UNITED STATES PATENT AND TRADEMARK OFFICE

APPLICATION NO.	FILING DATE	FIRST NAMED INVENTOR	ATTORNEY DOCKET NO.	CONFIRMATION NO.
10/707,168	11/25/2003	Yash Sinha	2002-039	1167
32170	7590	08/04/2006	EXAMINER	
U.S. ARMY TACOM-ARDEC ATTN: AMSTRA-AR-GCL BLDG 3 PICATINNY ARSENAL, NJ 07806-5000			POLLICOFF, STEVEN B	
			ART UNIT	PAPER NUMBER
			3728

Office Action Summary	Application No. 10/707,168	Applicant(s) SINHA ET AL.	
	Examiner Steven B. Pollicoff	Art Unit 3728

FIG. 1

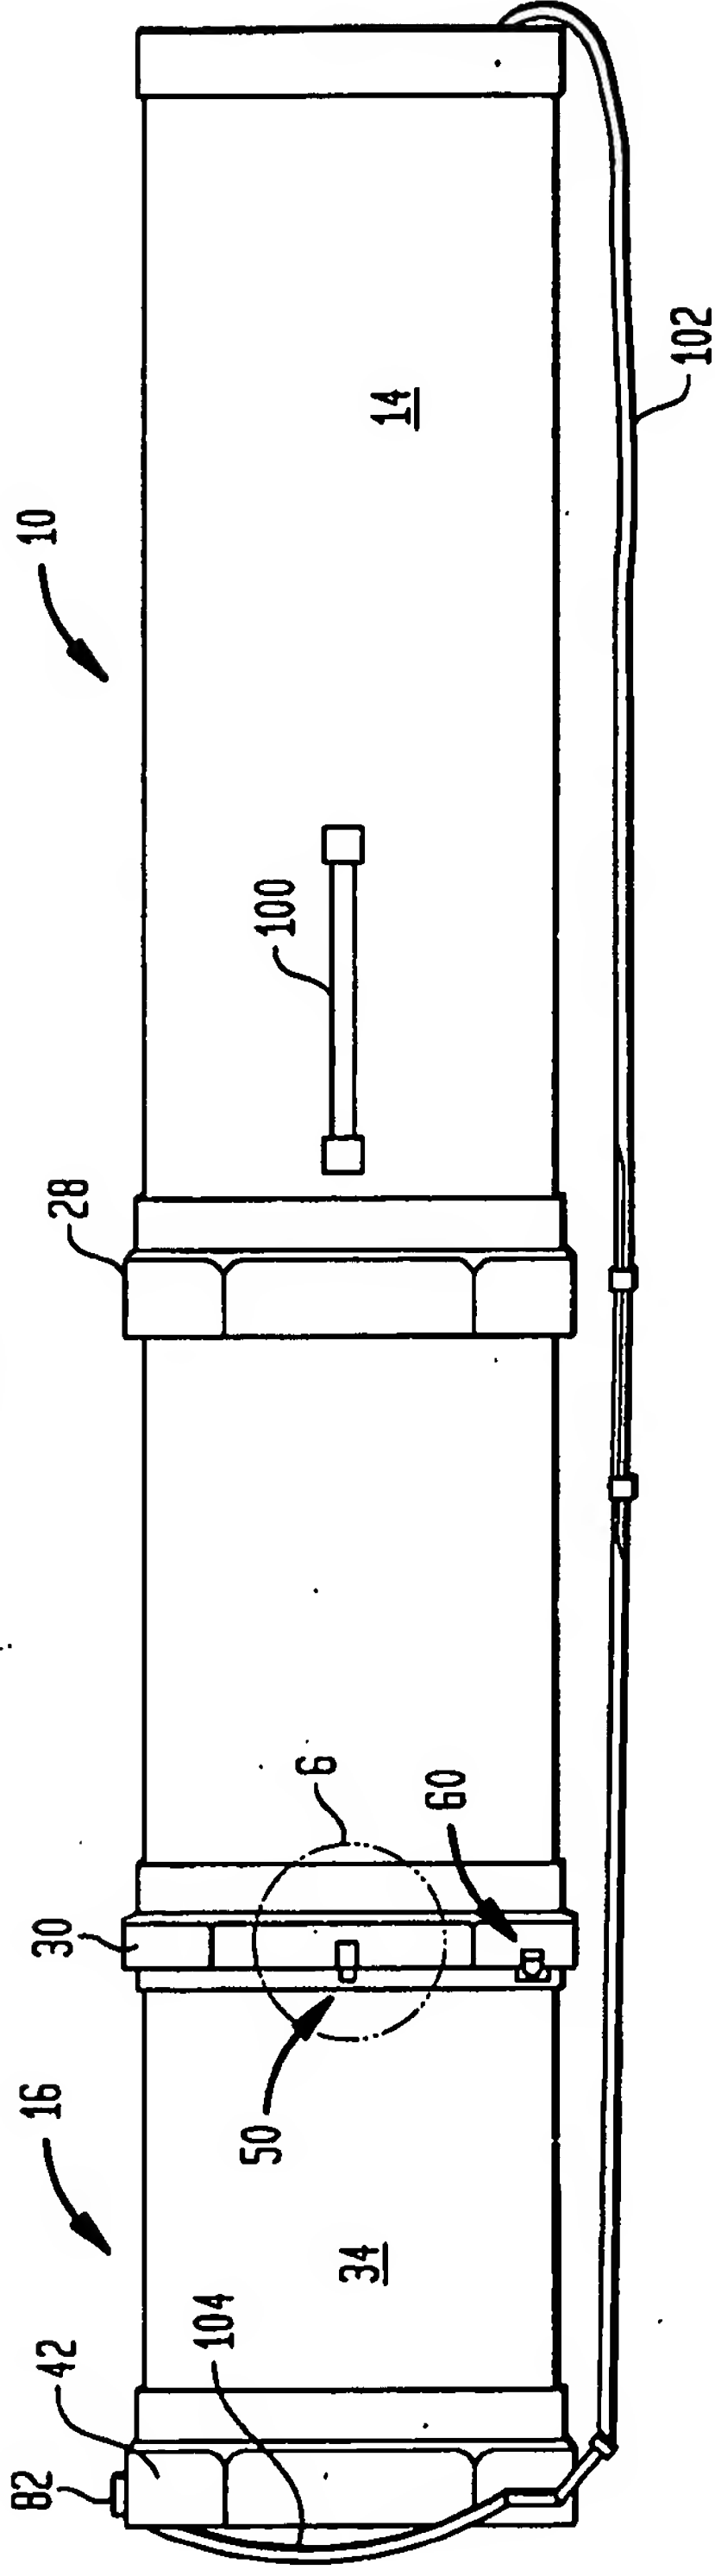
The drawings are objected to under 37 CFR 1.83(a). The drawings must show every feature of the invention specified in the claims. Therefore, the first and second bottom members of claim 1 and the octagonal impact rings of claim 7 must be shown or the feature(s) canceled from the claim(s). No new matter should be entered.

The amendment to the drawings filed 12/04/03 is objected to under 35 U.S.C. 132(a) because it introduces new matter into the disclosure. 35 U.S.C. 132(a) states that no amendment shall introduce new matter into the disclosure of the invention. The added material which is not supported by the original disclosure is as follows: The elimination of an octagonal bottom cap ring and connected shoulder strap in the amended drawings is considered new matter.

Applicant is required to cancel the new matter in the reply to this Office Action.

DRAWINGS NOT APPROVED FOR ENTRY
